WEST DAPTO URBAN RELEASE AREA and ADJACENT GROWTH AREAS

Proposed water and wastewater services

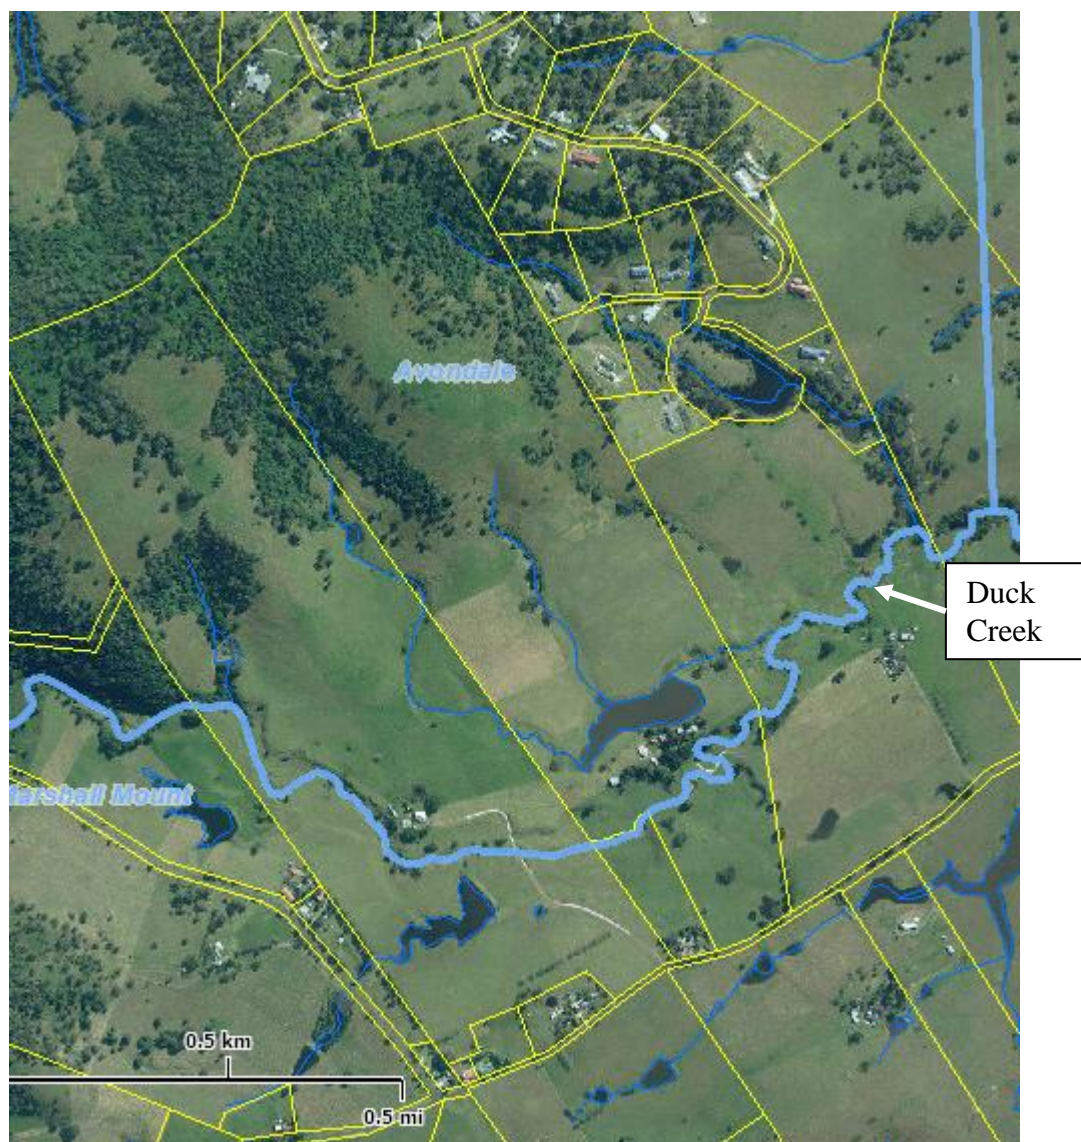
In particular we are interested in the specific trunk infrastructure that is proposed to be located on our property 386 Marshall Mount Road, Marshall Mount.

The proposed waste water pipeline shown on page 2 of the WDURA Fact Sheet, dated May 2011 is indicated to be located near the southern boundary of our property, on the southern side of Duck Creek. We are concerned that this location fails to service developable land located on the northern side of Duck Creek.

We think extending this pipeline to North Marshall Mount Road on the northern side of Duck Creek will better service this area of Yallah/Marshall Mount. We consider that locating the waste water pipeline along the creekline would allow for gravity assisted discharge, whilst avoiding impact upon developable land.
